Hi-Fi Products
Service Bulletin

Model: DTC-87ES

No. 309

Subject: Tape Won't Load

MECHANISM SECTION 5 (DATM-51)

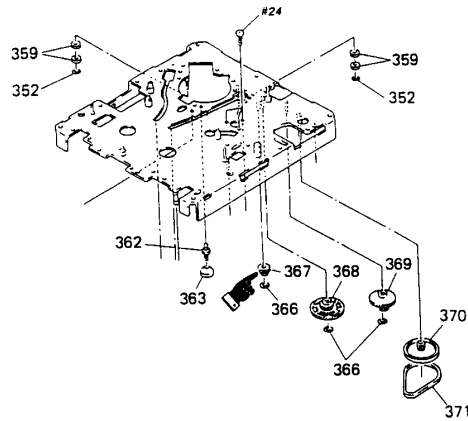
Mechanism will not load tape due to a cracked loading gear B (ref. 367) which is damaged by mechanical overload.

Solution: Replace loading gear B (ref. 367) with an improved type as shown in the chart below.

| REF | DESCRIPTION | PART NUMBER | |
|-----|------------------|--------------|--------------|
| 367 | GEAR (LOADING B) | 3-345-182-01 | 3-372-619-01 |
